## IDAP REPORT – SECTION 4.55(1A) MODIFICATION

<b>Property:</b>	3 Wakeford Road STRATHFIELD LOT: B DP: 386343 DA2021.89.2
<b>Proposal:</b>	Section 4.55 (2) Modification Application for internal and external alterations to approved dwelling house.
<b>Applicant:</b>	M Hijazi
<b>Owner:</b>	Northpoint Living Pty Ltd
<b>Date of lodgement:</b>	21 January 2022
<b>Notification period:</b>	31 January 2022 to 14 February 2022
<b>Submissions received:</b>	NIL
<b>Assessment officer:</b>	G I Choice
<b>Estimated cost of works:</b>	\$1,426,072.00
<b>Zoning:</b>	R2-Low Density Residential - SLEP 2012
<b>Heritage:</b>	No
<b>Flood affected:</b>	No
<b>RECOMMENDATION OF OFFICER:</b>	APPROVAL

Figure 3: Proposed roof plan

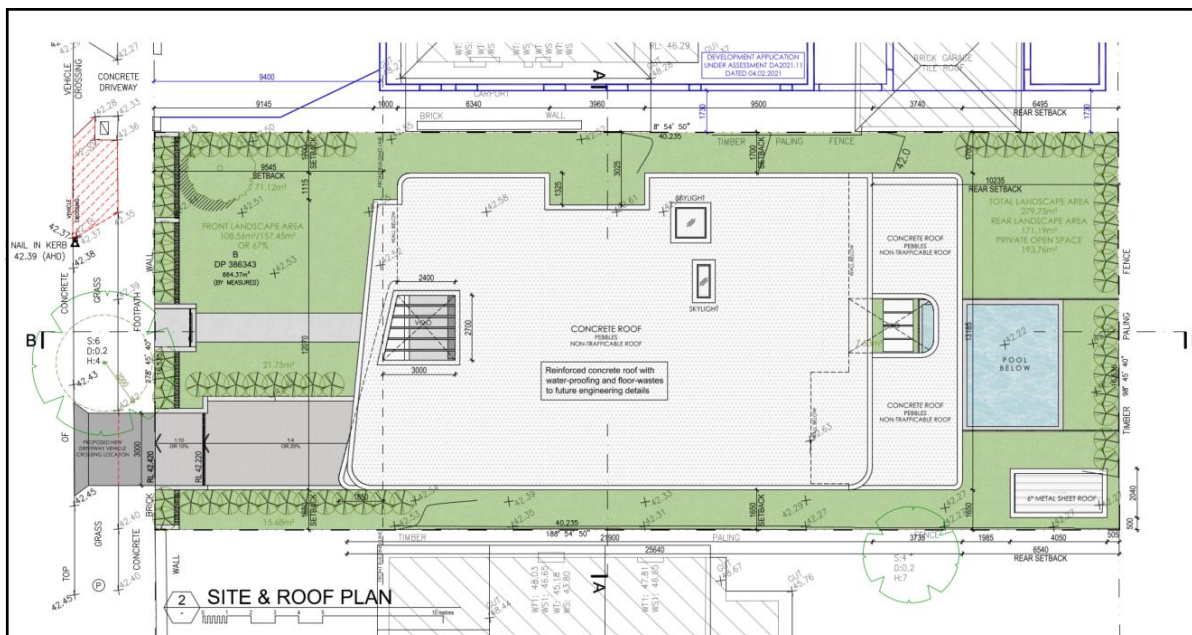
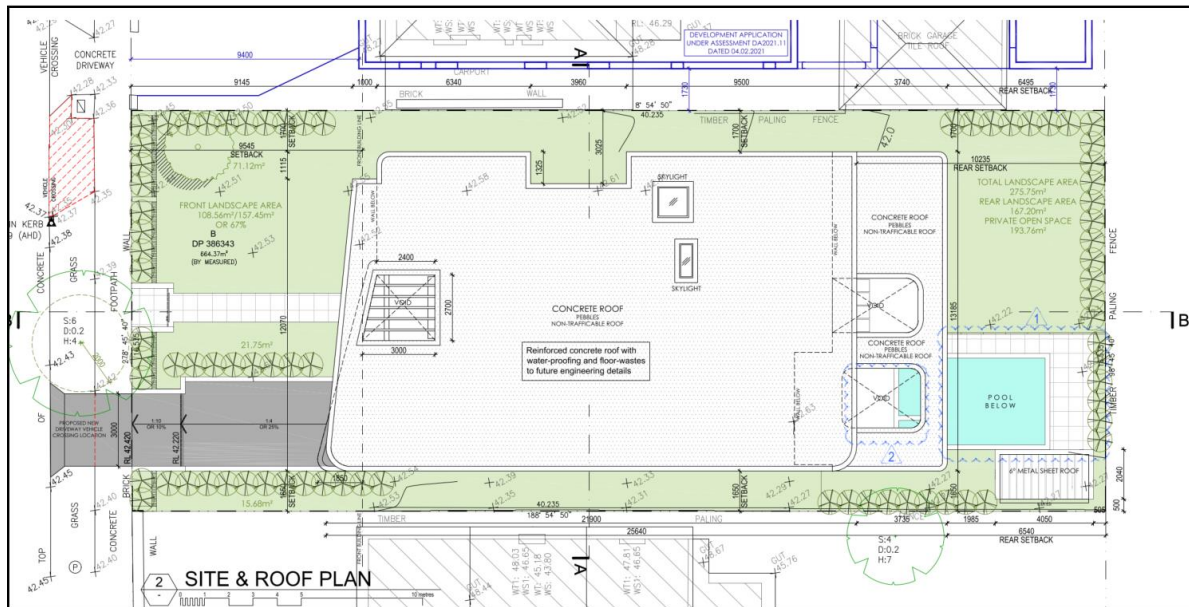
The proposed flat roof building height increase remains below the 7.8m SCDGP HOB control for flat roof dwellings and will sit more than a metre below the pitched roofs of the existing dwellings of the adjoining No.1 and No.5 Wakeford Road properties.

The height of the building measured from Australian Height Datum (AHD) must not exceed Relative Level (RL) RL 49.75 AHD to the ridge of the building.

Figure 5: Proposed Ground Floor plan

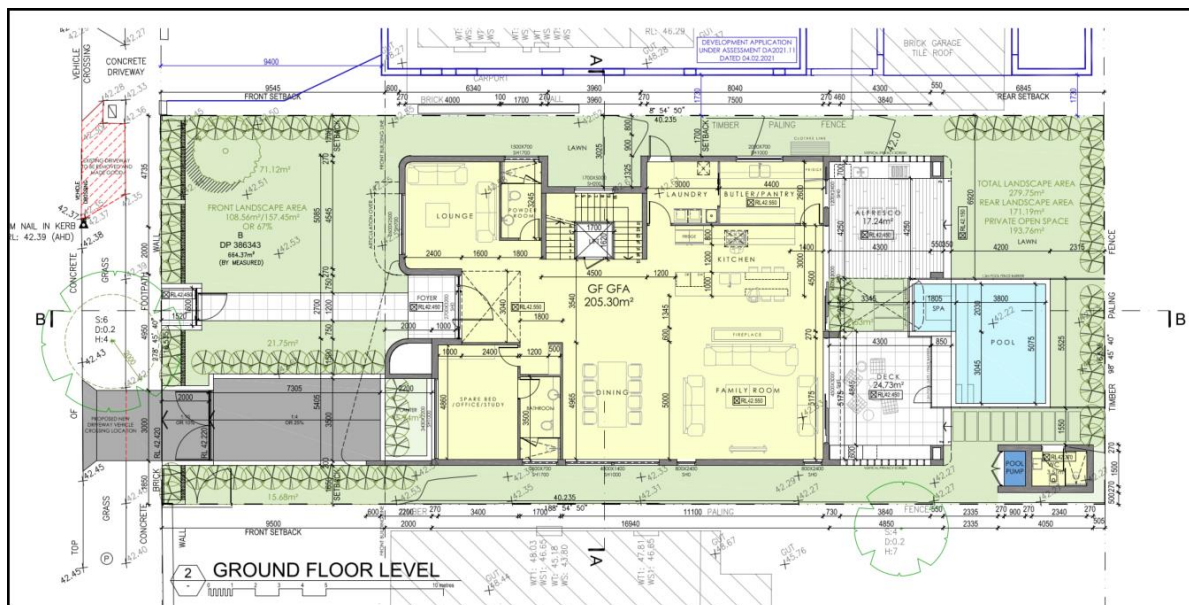
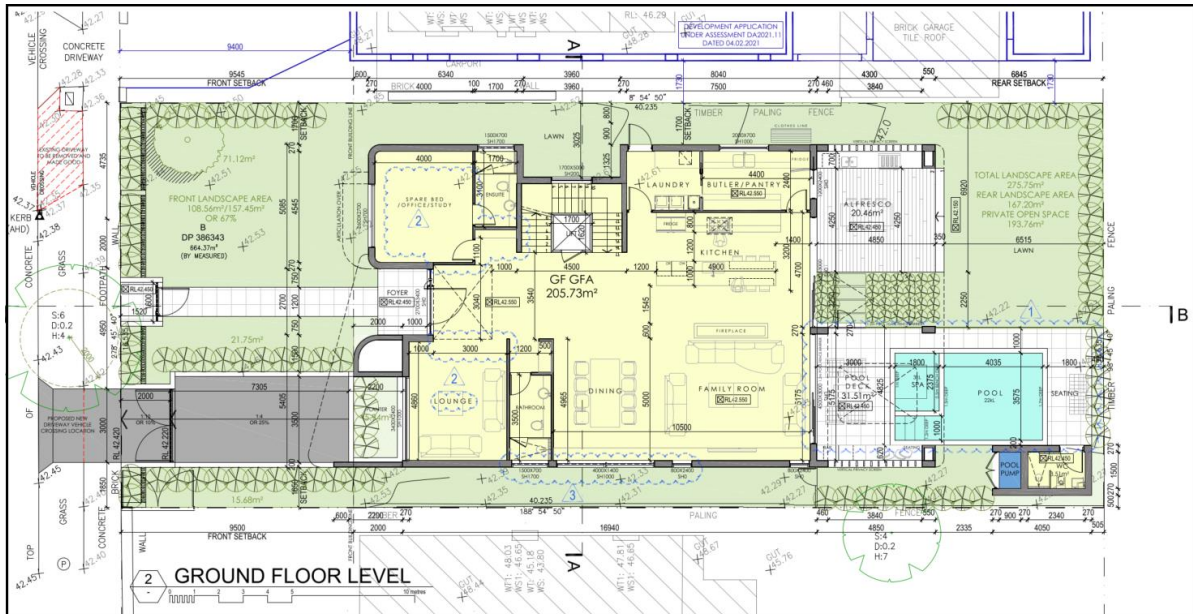
- Reconfiguration of lounge and spare bed/study room
- Shift of bathroom 600mm and slight reduction of dining/family room
- Increase of floor to ceiling heights from 3.2m to 3.4m

Ground floor to ceiling heights are proposed to be increased. This includes the increased height of the family room from 3.2m to 6.7m as a result of the void as well as an overall ground floor to ceiling heights increase from 3.2m to 3.4m; and first floor ceiling heights from 2.8m to 3m. The building height is proposed to increase by 400mm, however the overall building height remains below the 7.8m height limit for flat roof dwellings as per SCDGP and the modification is considered acceptable.

The proposed void does not result in an increase in visual bulk from the exterior and is in the place of previously approved floor area. On balance, the void is acceptable.

Figure 7: Proposed first floor plan

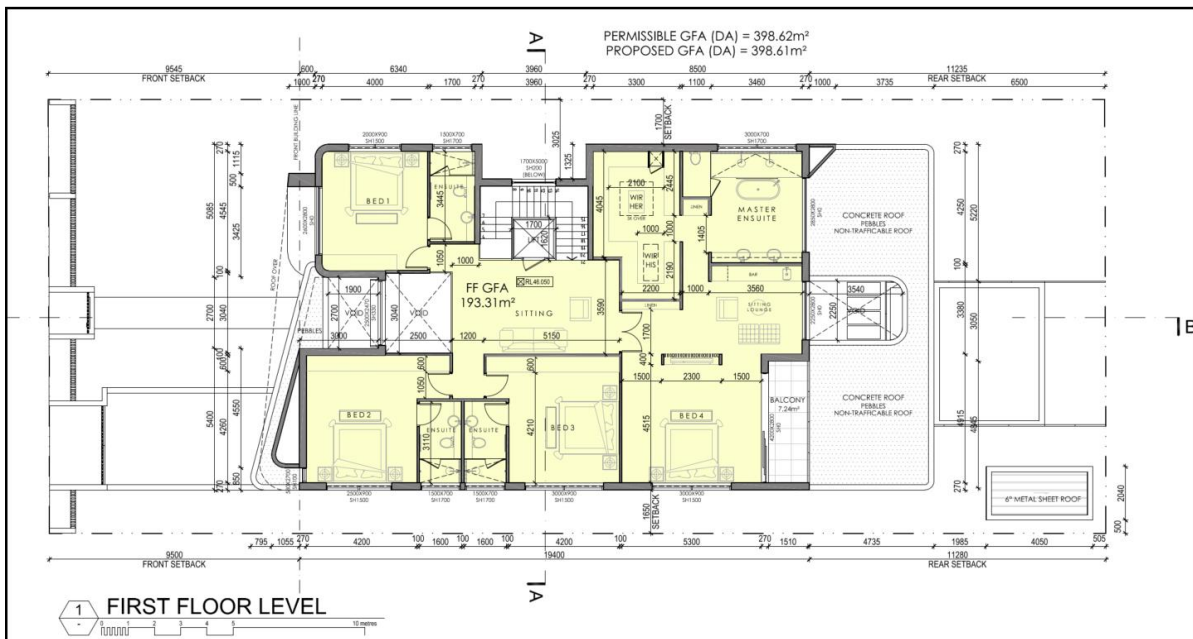
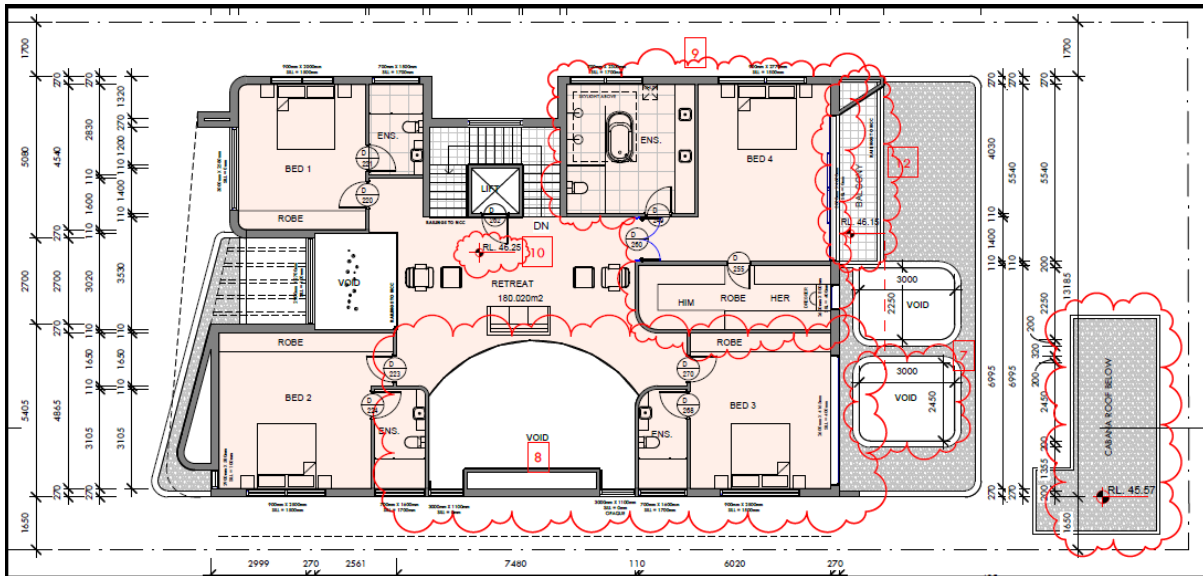
- Increase of floor to ceiling heights from 2.8m to 3m

The proposed development, as modified, includes the relocation of the first floor balcony from the rear north-east corner (new Bed 3) to the north-west corner (new Bed 4). The proposed balcony is screened by a return on the west elevation and an existing condition shall be retained (and modified accordingly to install a privacy screen to prevent overlooking into the rear yard of 1 Wakeford Road.

The proposed Bedroom 4 balcony exceeds the 1m x 2m size control, however, the installation of a privacy screen will prevent overlooking to 1 Wakeford Road. Overlooking impacts to other adjoining properties are minimal. This is considered a better outcome for the amenity of the occupants.

Privacy Screen	A privacy screen shall be provided to the first floor balcony of Bedroom 4. The privacy screen is to be a minimum of 1.8m high from the finished floor level of the balcony and comprise of a material that cannot be seen through, such as translucent glazing. If louvres are to be used, they are to be fixed in a position that does not allow downward viewing of the adjoining properties.
----------------	--

Figure 9: Proposed south & east elevations

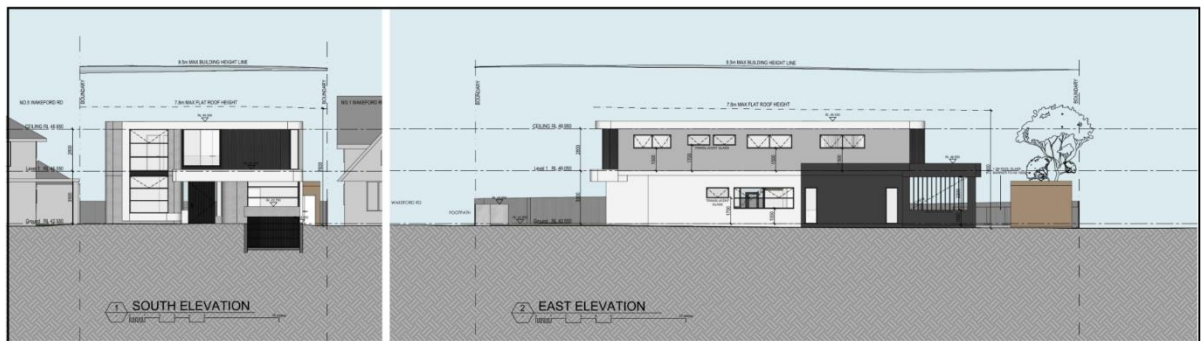
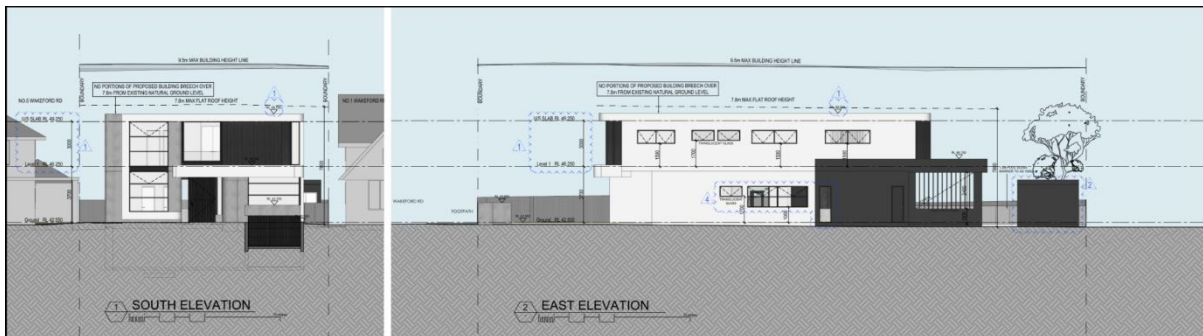
- Changes to materials and finishes schedule
- Reconfiguration of pool area and additional paved seating area
- Overall building height increase of 400mm

Applicable DCP Controls	DCP Controls	Development Proposal	Compliance/ Comment
<b>Building Envelope</b>			
<b>Heights:</b>			
Floor to ceiling heights:	3.0m	Ground void : 6.7m	No - see discussion
Height to underside of eaves:	7.2m	6.98	Yes
Parapet height:	0.8m	0.5m	Yes
Overall height for flat roof dwelling:	7.8m	7.48m	Yes
